**RE: Effluent Field, Mehrtens Residence, U021236**

## **Application for Resource Consent-Mehrtens, Kelvin**

**Application for Resource Consent**  
**Mehrtens, Kelvin**  
**Worlds End Road Penzance Bay Central Pelorus West**  
**Section 92 – Request for Further Information**

**RE: Effluent Field, Mehrstens Residence, Lot 15 Worlds End Road, Penzance Bay**

CAMERON GIBSON & WELLS LTD CONSULTING CIVIL & STRUCTURAL ENGINEERS	44 HALIFAX STREET NELSON  PH 548-8259 FAX 546-8412	Design	LR	Title  CONVENTIONAL BED DETAIL		
		Drawn	JH			
		Checked	LR			
		Approved	R6			
		Date	NOVEMBER 2002	Scale	Job No.	Sheet
				NTS	12050	2

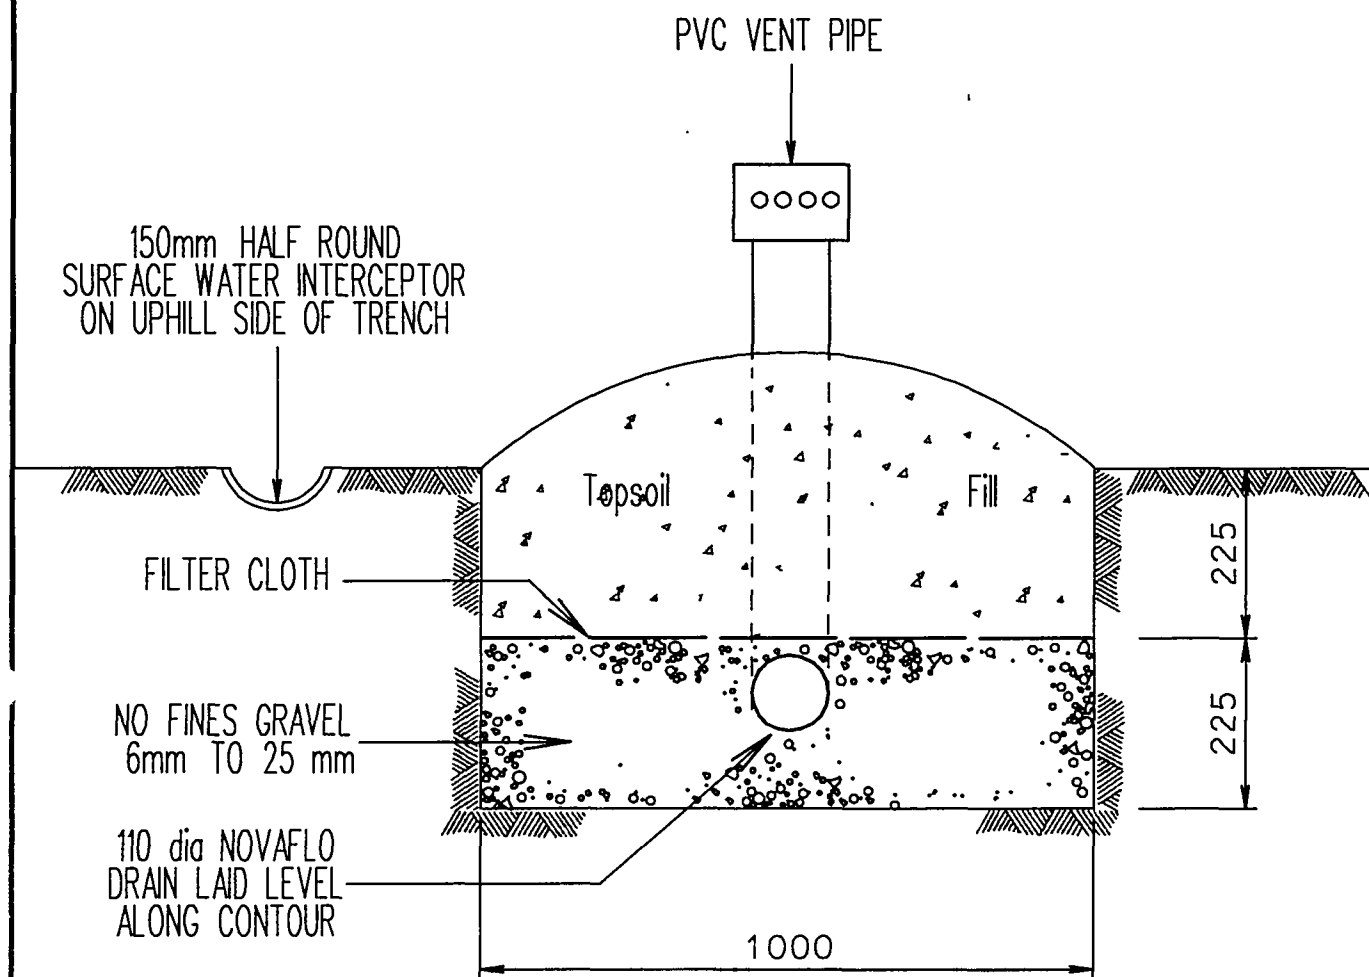
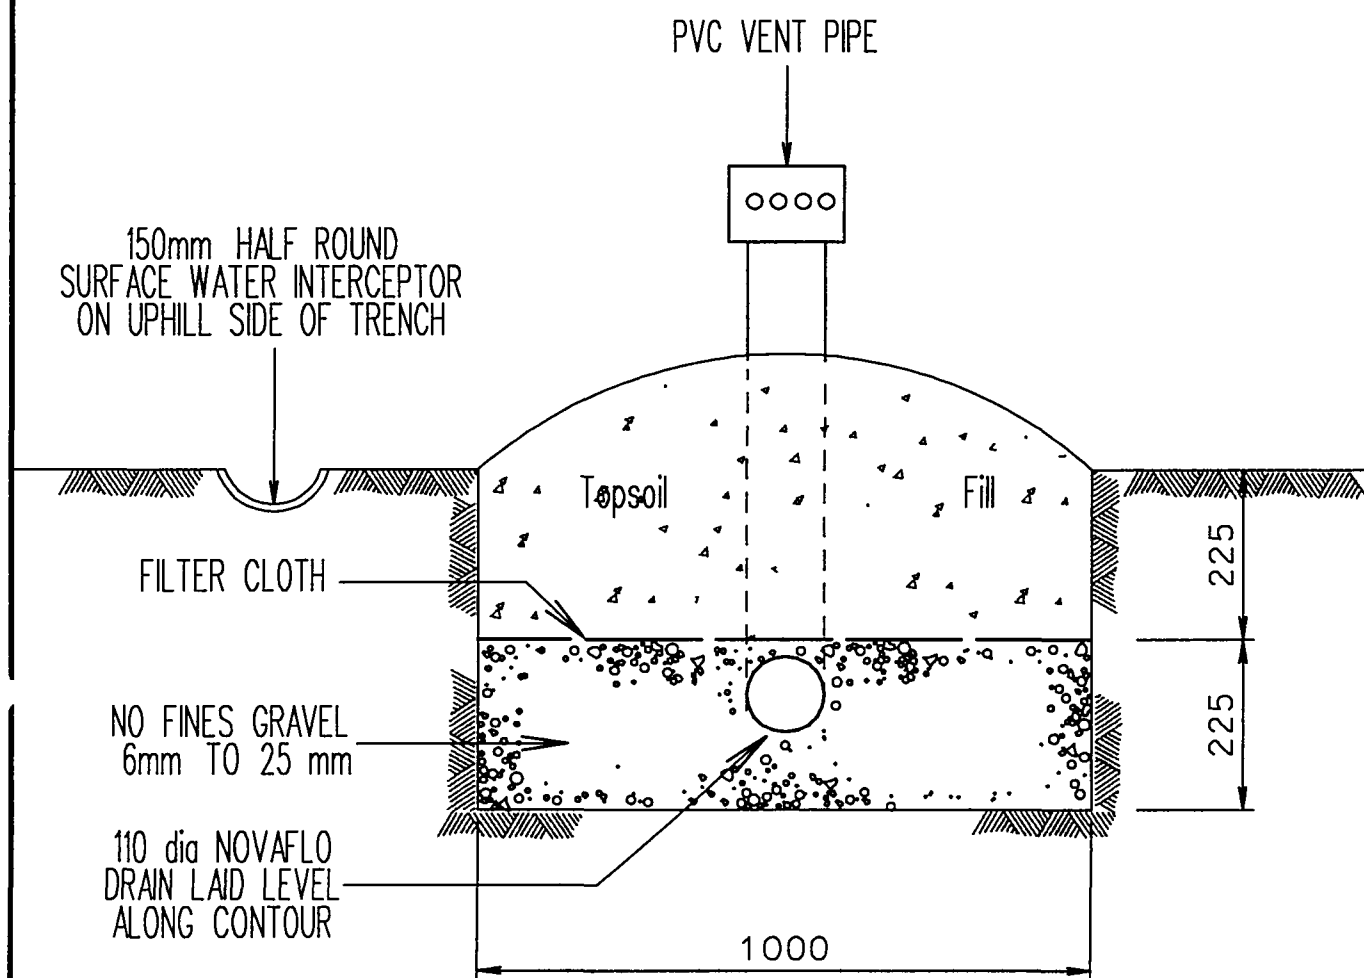
I note that the trench width in the application is 800 mm. AS/NZS 1547:2000 (table 4.5A1) gives a maximum trench width of 600mm.

After reviewing AS/NZS 1547:2000 I agree that the maximum trench width requirement is not logically explained and accept that a 1 metre bed/trench would be suitable for this site.

You have noted the proposed trench width of 800 mm is greater than the maximum trench width of 600 mm given in table 4.5A1 of AS/NZS 1547:2000. We would like to draw your attention to the fact that there is practically no difference between a conventional piped trench as shown in figure 4.5A1 and a conventional bed as shown in figure 4.5A5 apart from the width. In fact, a conventional bed could be 1 m wide and have only one distribution pipe. Whereas, a conventional trench can be up to 600 mm wide and has one distribution pipe. As the design loading rates for trenches and beds are the same, and the DLR relates to the size of the horizontal bottom area, the only difference between a 600 mm wide trench and a 1.0 m wide bed would be the total length of the system.

We do not see any reason why we do not use a trench 800 mm wide, as it fits with all other requirements of a trench and a bed, and is a practical width for an excavator.

Drawing Title  
**EFFLUENT FIELD  
LAYOUT**

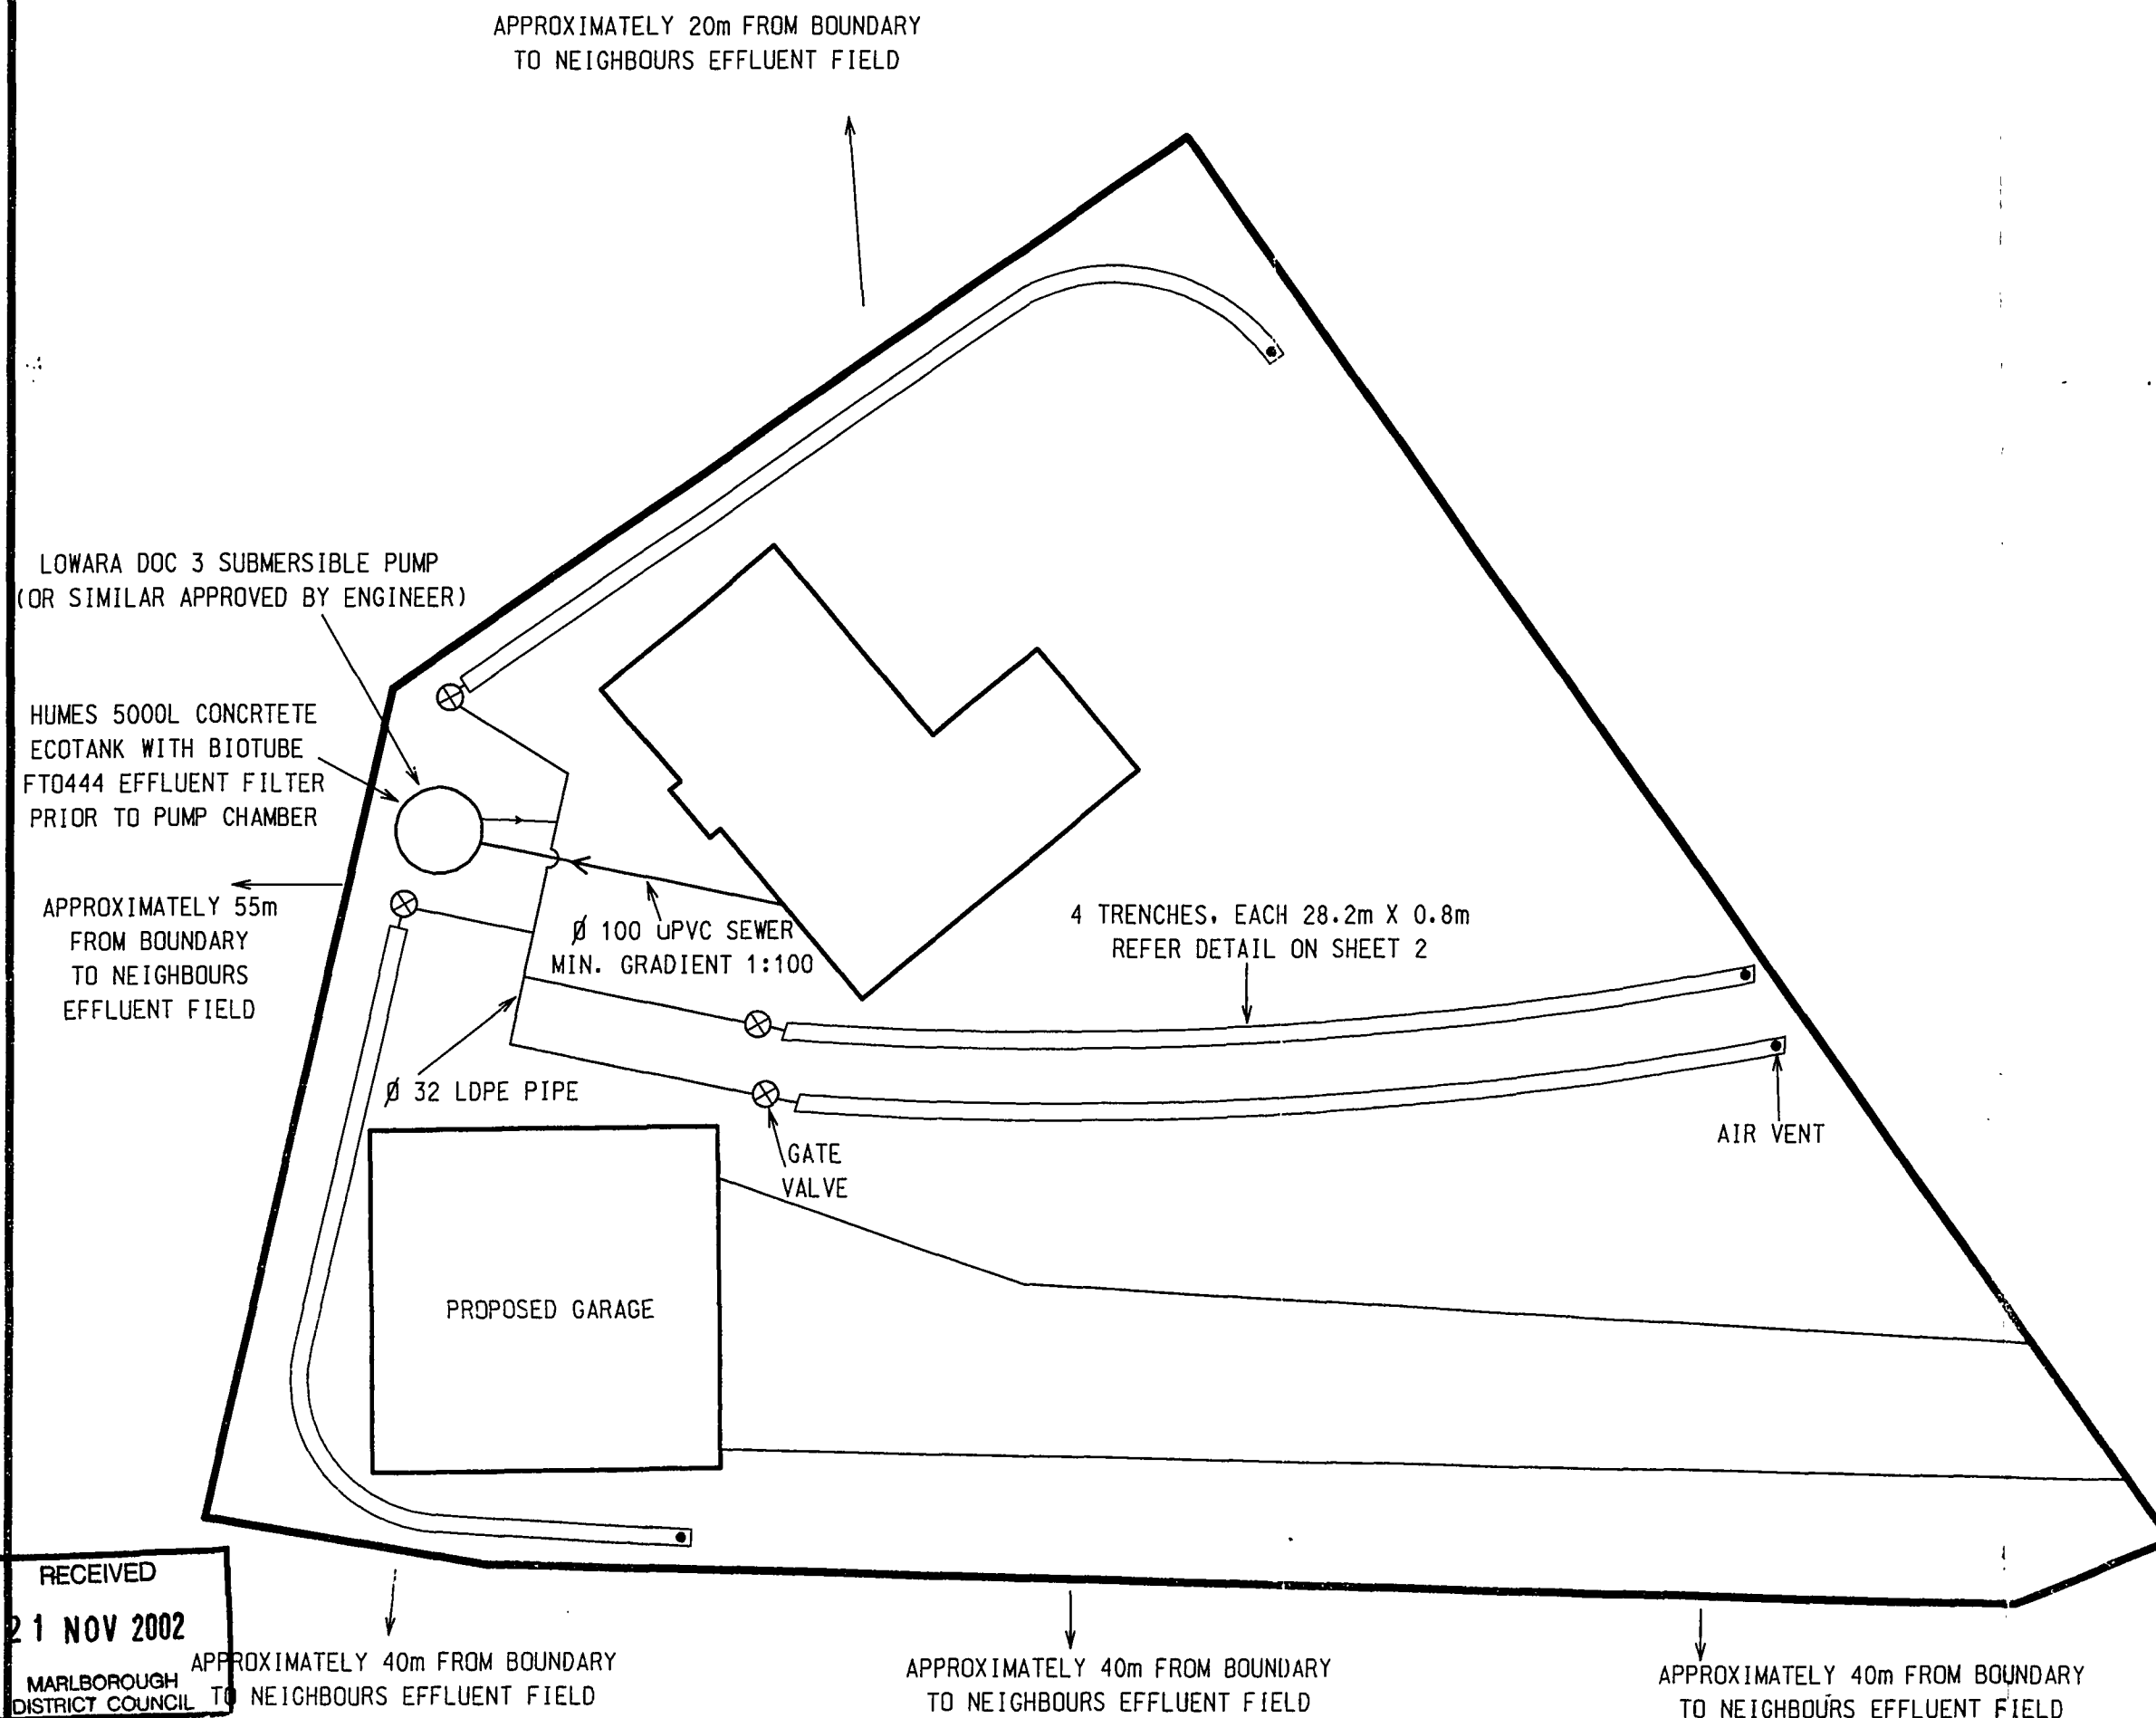
With regard to my question regarding the northern trench, I assumed that you were familiar with the site and that the difficulties of installing a trench, as shown on the site plan, (required to be flat through all of the 28.2 m proposed length) when taking into account the slope of the ground would be apparent.

Also after recently visiting the site it appears that the topography in the area of the proposed northern trench would make installation problematic and the trench is unlikely to operate satisfactorily.
